00 91 03 ADDENDUM NUMBER 03

Owner: City of Wilson, North Carolina
Project: Goldsboro Ph II Water Main Replacement (SRP-D-ARP-0125)
Project No.: WLN22846
Addendum No. 03
Addendum Date: May 2, 2024

CITY OF WILSON
GOLDSBORO PHASE II WATER MAIN REPLACEMENT
 24" WATER MAIN
PLAN AND PROFILE
GOLDSBORO ST - STA 10+00.00 TO STA 18+00.00

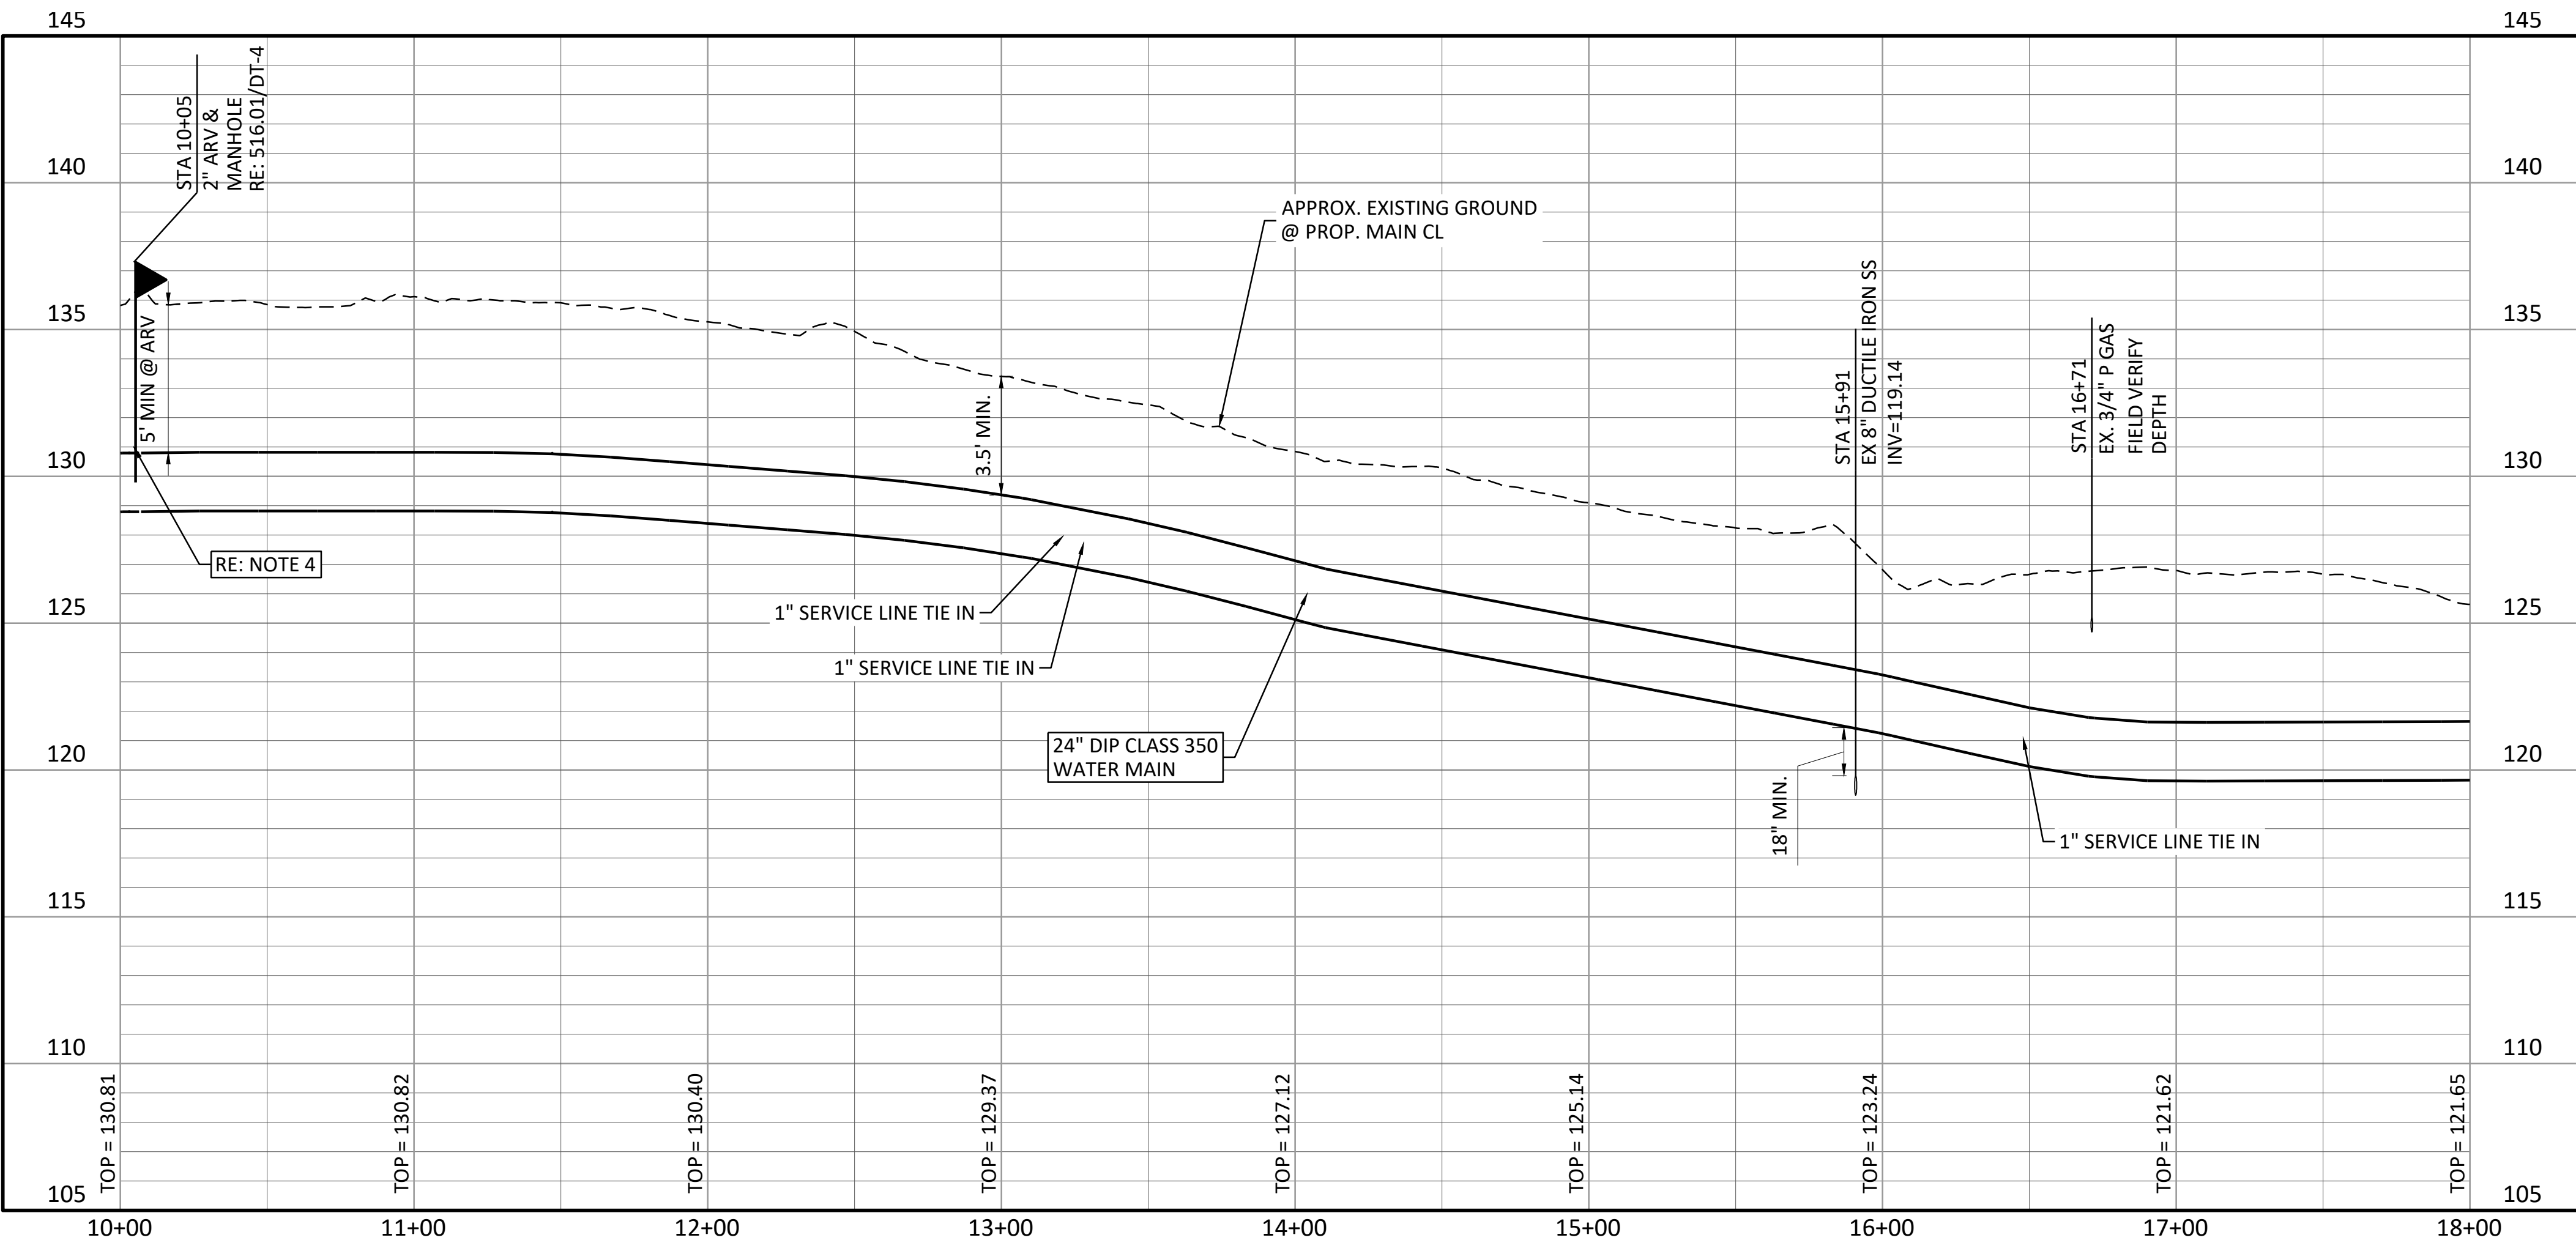
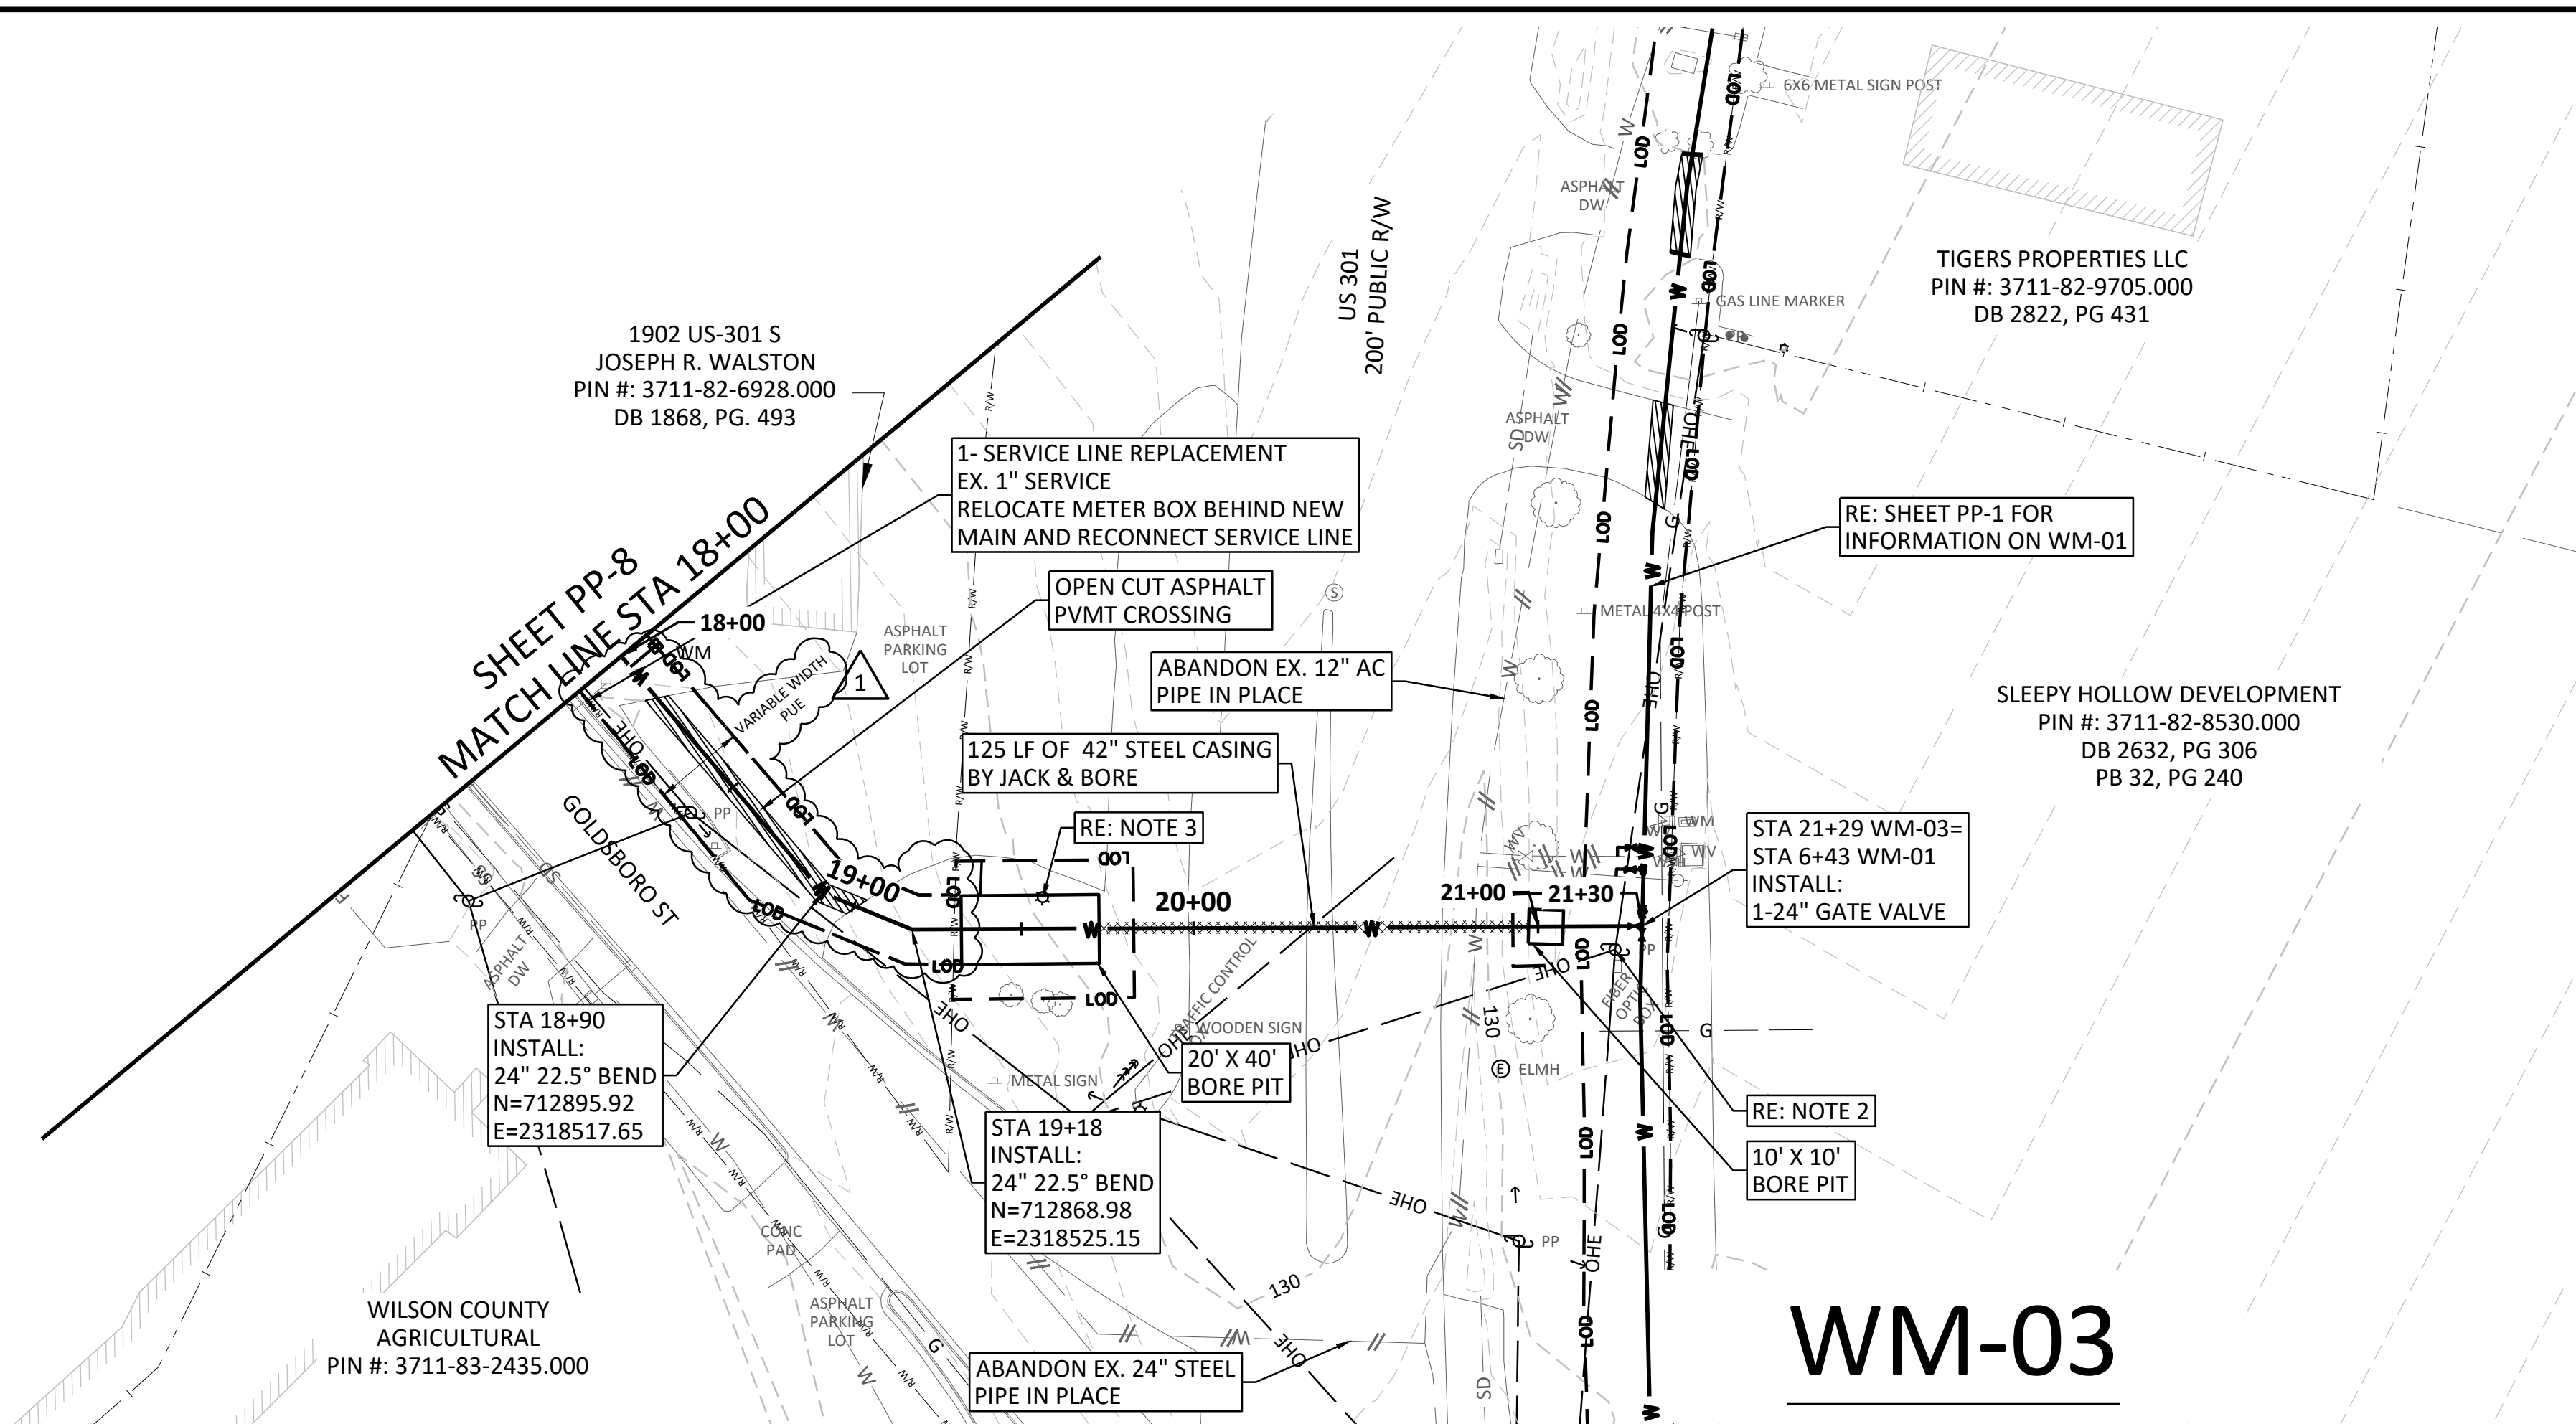
3.01 Sheet PP-8 “Plan and Profile Goldsboro St – Sta 10+00.00 to Sta. 18+00.00”

- A. Amend callout located in Plan View at STA 10+05 as follows:

1. QUESTION: Will you please confirm the sizes of ARV assemblies? Plans show 2ea 12x2, 1ea 16x2 and 1ea 24" but plan view calls out 4" and profile view calls out 2" (sheet PP-8). There seem to be no 3" ARVs on the plans, but 2ea are called out on the bid form.

INSTALL
1 – 2” ARV & MANHOLE
N=713763.28
E2318693.33

RESPONSE: City of Wilson would like to use 2" ARVs on all mains. The plans (PP-8) and bid form have been updated accordingly.
2. QUESTION: Are domestic requirements required based on ARPA funding?
